9632 STONEBRIDGE WY

6834B County Permit Review Worksheet

Residential Subsurface Wastewater Treatment and Disposal System Design

GWS Septic System Design Review

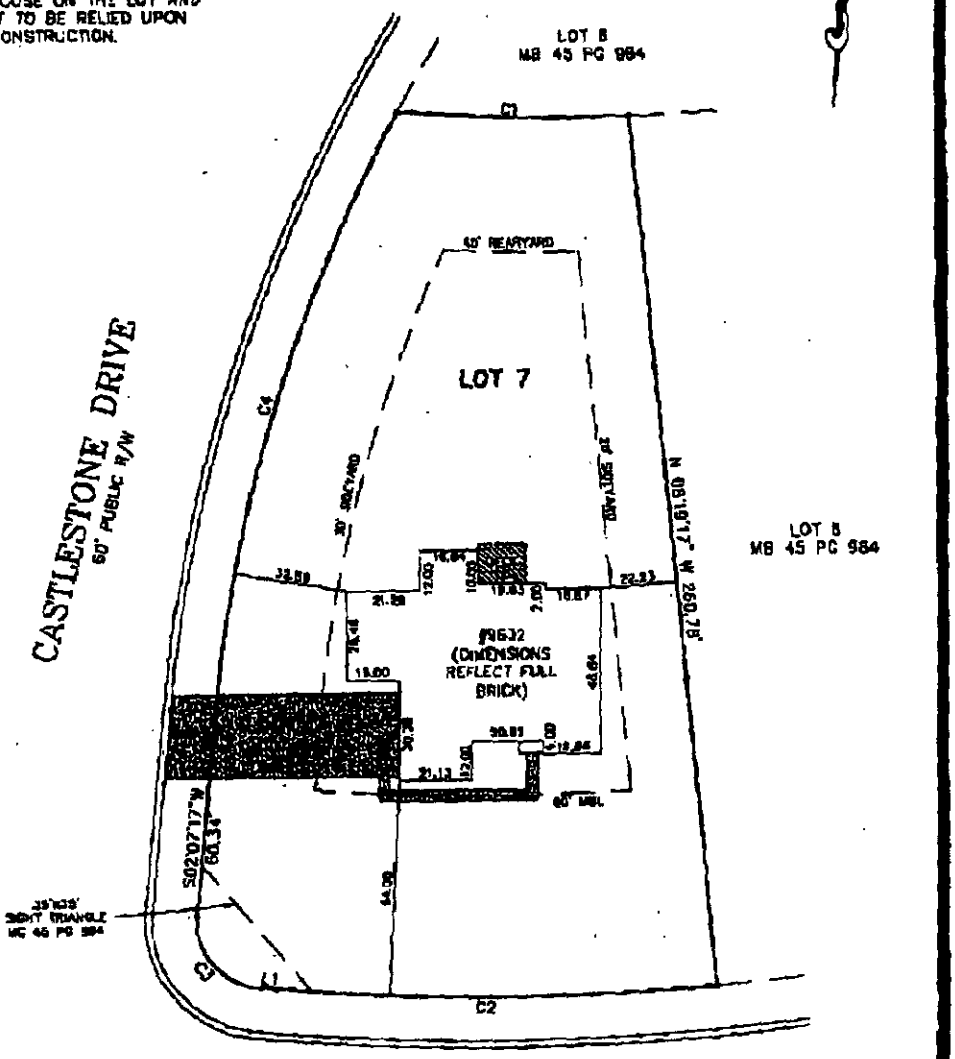
- REVISE CALCULATIONS FOR CORRECT LTAR VALUE.

— 0.25 LTAR ASSIGNED BY BWS L.S.S.

& LTAR. 0275 ALLOWED AS SHOWN IN PLANS. 3-29-07

PROPOSED MODEL FIT

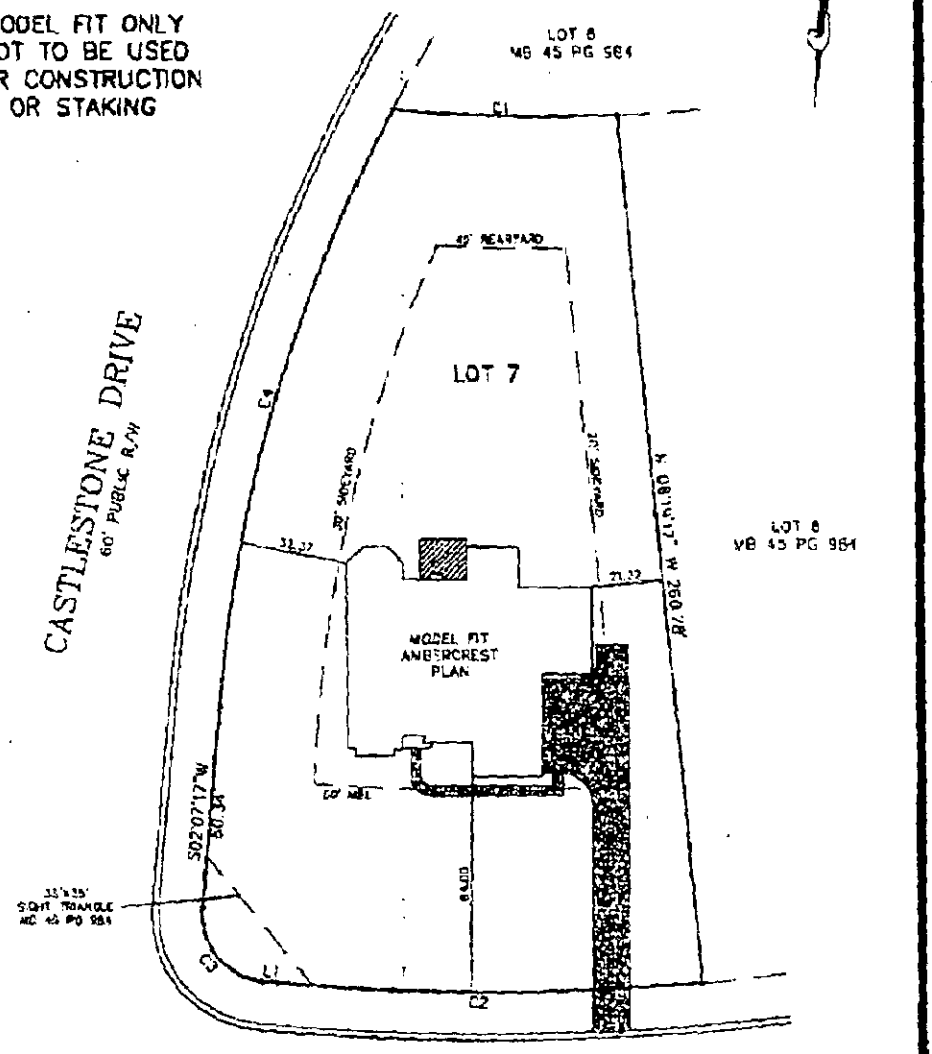
① NEED NEW/REVISED APPLICATION ON FILE TO REFLECT CORRECT # OF BEDROOMS.
- SOIL REPORT INDICATES 5 BEDROOM EVALUATION.
- DESIGN IS FOR A 4 BEDROOM HOUSE.

③ PLAN DISAPPROVED AND WILL REQUIRE REVISIONS.
